420 kV CAPACITOR VOLTAGE TRANSFORMER TYPE: CPB-H 420

END CUSTOMER:
APTRANSCO

Chief Engineer/Projects
APTRANSCO/VS/Vijayawada.

LIST OF DOCUMENTS FOR CPB-H 420 TYPE CVT

Revision				DRAWN: SR	CHECKED: SNP	APPRD.: SN	file: - 3320-085	TOTAL SH. 1
A	2022-07-07						1HYT903320-085	Sh. NO. 1

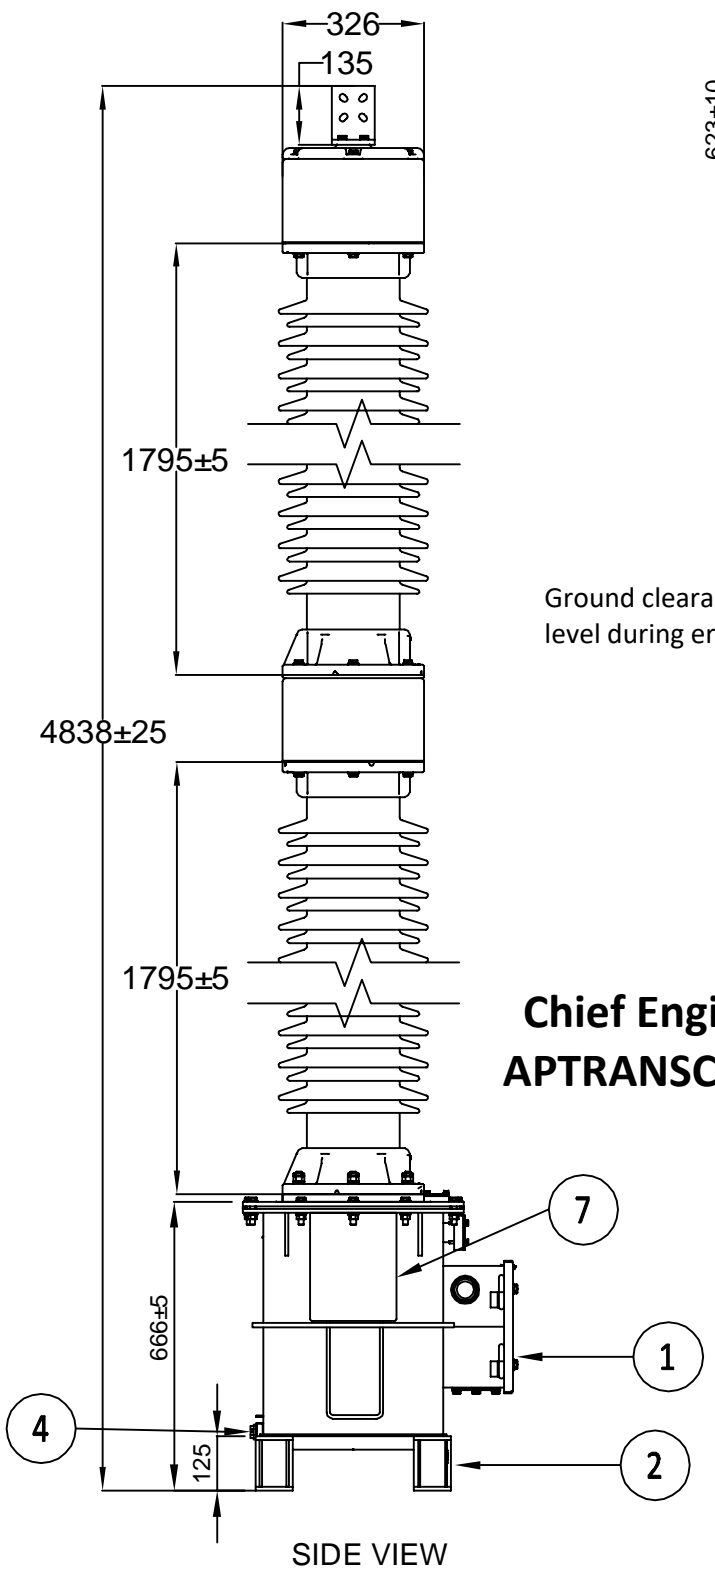
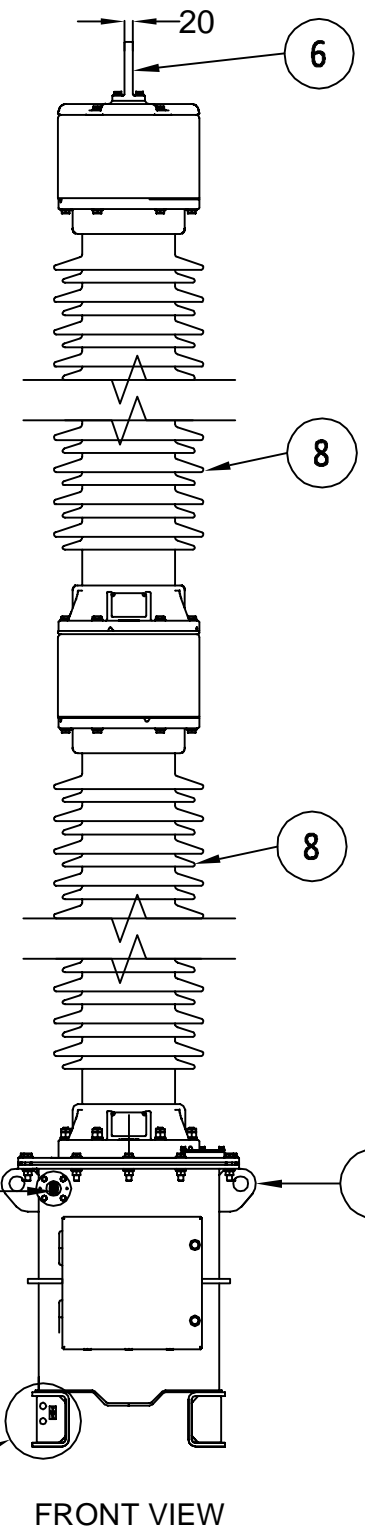
Since the supply of terminal connectors is not in the scope of Manufacturer as mentioned in the drawings The EPC contractor shall be instructed to supply the same in line with CT/PT/CVT/Isolator/VT/LA/Breakers, requirement and capability.

Ground clearance of 8000mm shall be maintained from plinth level during erection.

Revision		420 KV Capacitor Voltage Transformer Type: CPB-H 420	SECTIONAL VIEW	DRAWN: SR	CHECKED: SNP	APPRD.: SN	file: 3320-088	TOTAL SH. 1
A	2022-07-07			HITACHI ENERGY INDIA LIMITED (FORMERLY KNOWN AS APPSIL)			1HYT903320-088	Sh. NO. 1

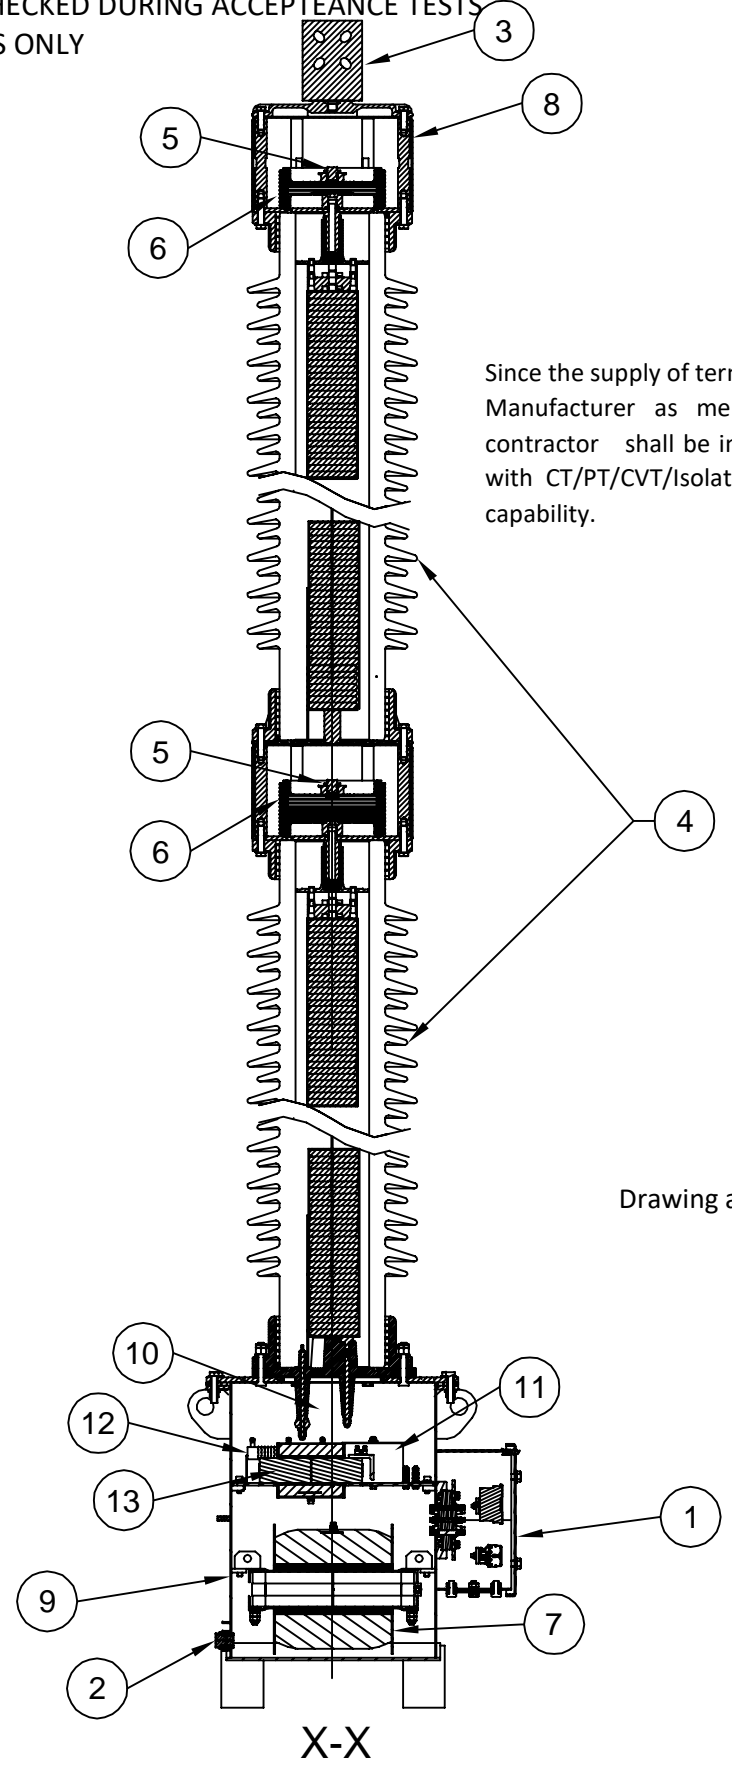
Ground clearance of 8000mm shall be maintained from plinth level during erection.

Since the supply of terminal connectors is not in the scope of Manufacturer as mentioned in the drawings The EPC contractor shall be instructed to supply the same in line with CT/PT/CVT/Isolator/VT/LA/Breakers, requirement and capability.

Revision		420 kV Capacitor Voltage Transformer Type: CPB-H 420	INSULATOR DRAWING (31 mm/kV)	DRAWN: SR	CHECKED: PDS	APPRD.: SN	file: - 3320-089	TOTAL SH. 1
A	2022-07-07			HITACHI ENERGY INDIA LIMITED (FORMERLY KNOWN AS APPSIL)			1HYT903320-089

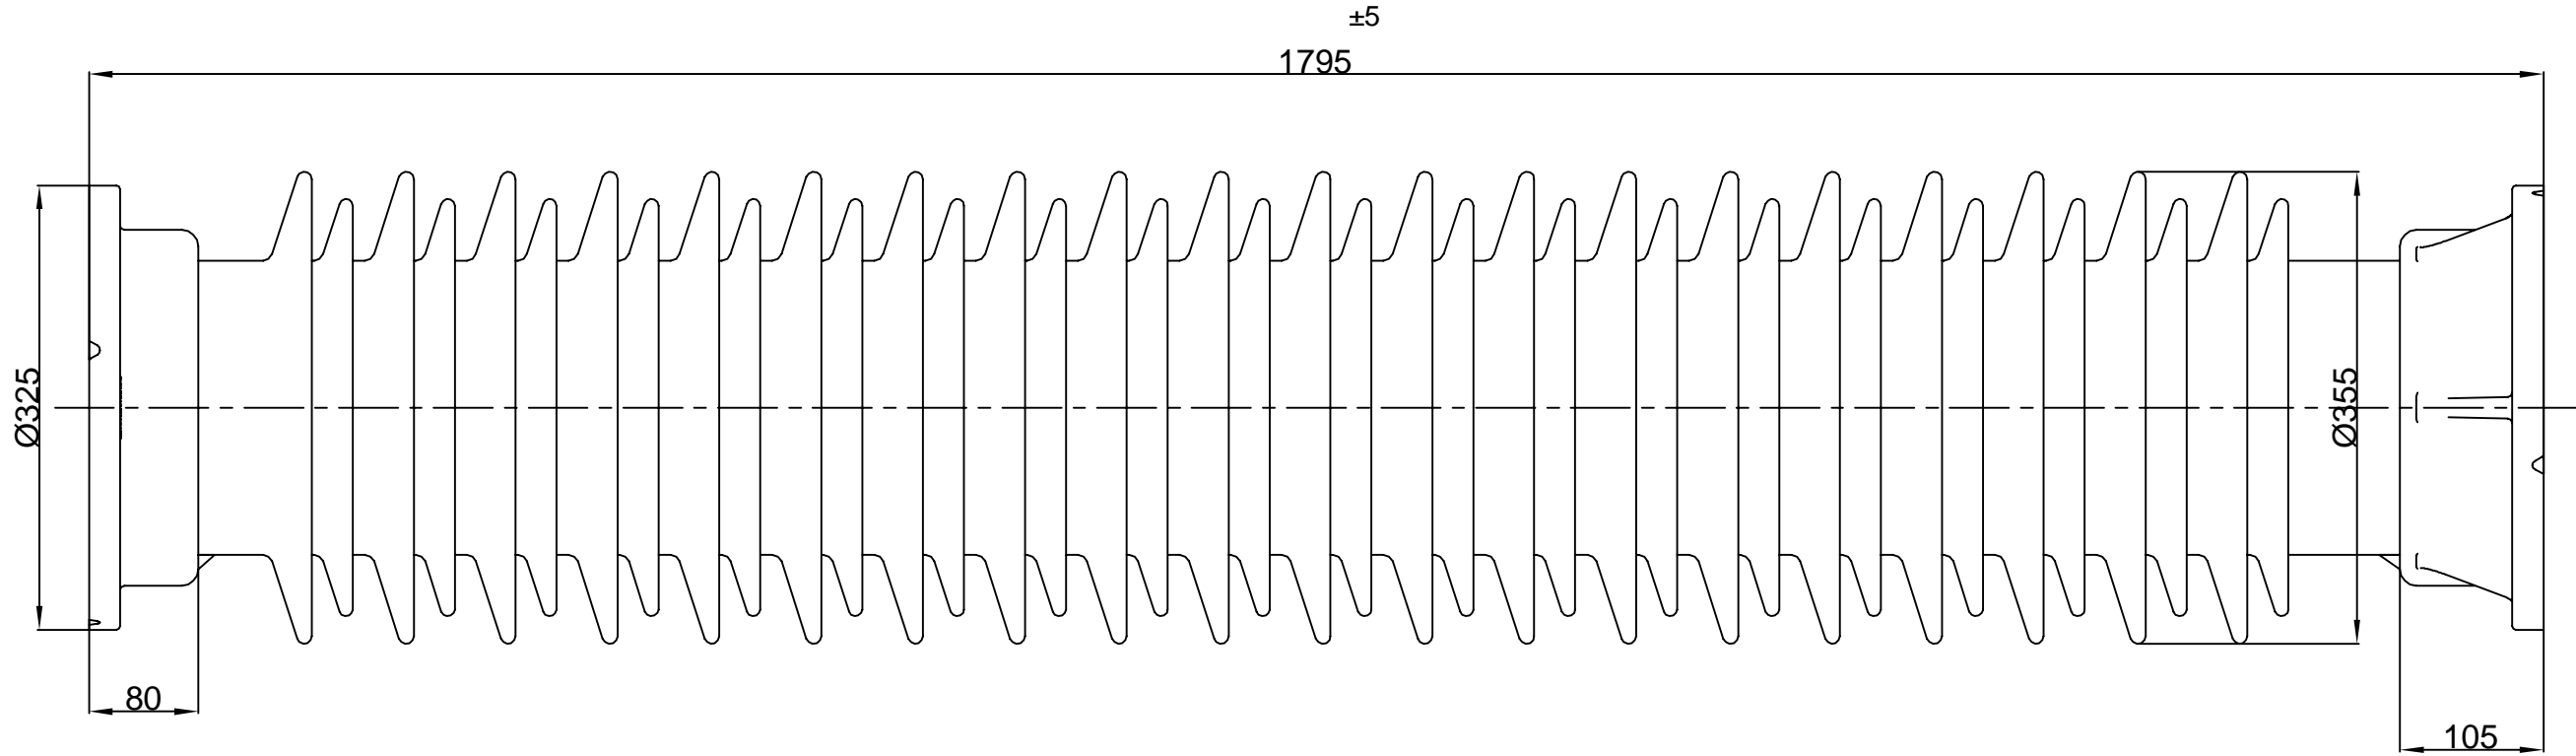
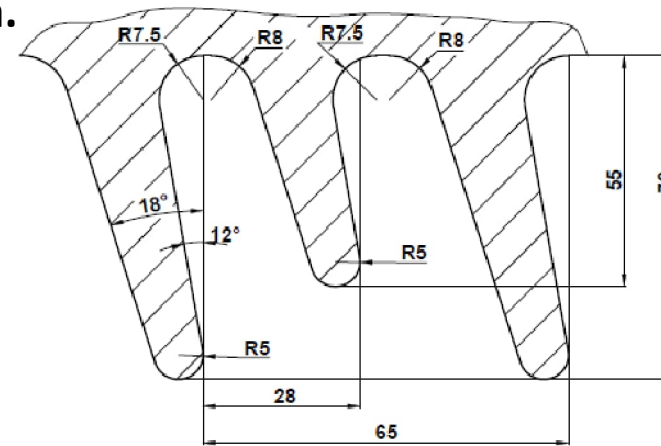
NOTE: 1. DRAWING APPROVAL SUBJECT TO VALID TYPE TEST REPORTS, TO BE CHECKED DURING ACCEPTANCE TESTS
2. FOR EPC CONTRACTS ONLY
